Addendum No.: 2
Date: 10/06/17

Project: **Midway**
Project No.: 17-0417.001

Subject: Canyon ISD – Midway
Addendum #2

Canyon ISD - Midway
SHEET SKE202a
DATE 10-06-17
Addendum #2

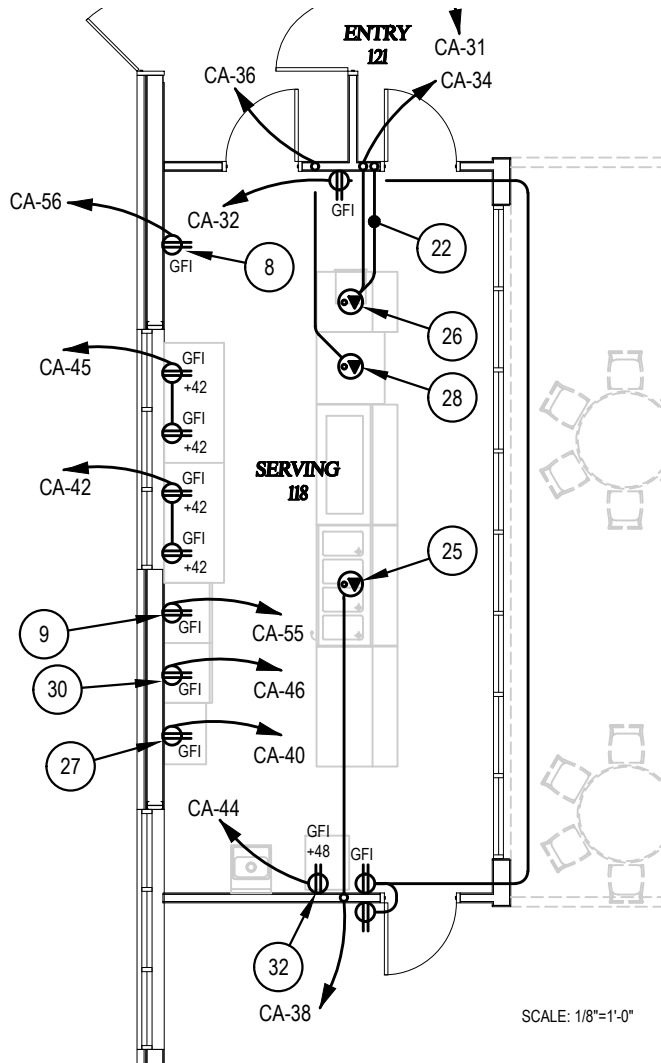
Item 1: Sheet E202: Revise keyed note 25 as indicated on attached Sketch SKE202a.

- 25 INSTALL RECEPTACLE IN A HUBBELL SA6688 ABOVE-FLOOR SERVICE FITTING WITH SS23 BLANK PLATE ON BACK SIDE AND SS703 SINGLE RECEPTACLE OPENING PLATE FOR RECEPTACLE ON FRONT. INSTALL A NEMA 5-50 RECEPTACLE IN FRONT PLATE. RUN WIRE AND CONDUIT FROM RECEPTACLE BELOW SLAB TO WALL, THEN UP IN WALL TO ACCESSIBLE CEILING SPACE. HOMERUN 2-8, 1-10G, 1\"C. CORE DRILL FIRST FLOOR AS REQUIRED FOR INSTALLATION. VERIFY EXACT LOCATION WITH OWNER PRIOR TO INSTALLATION.
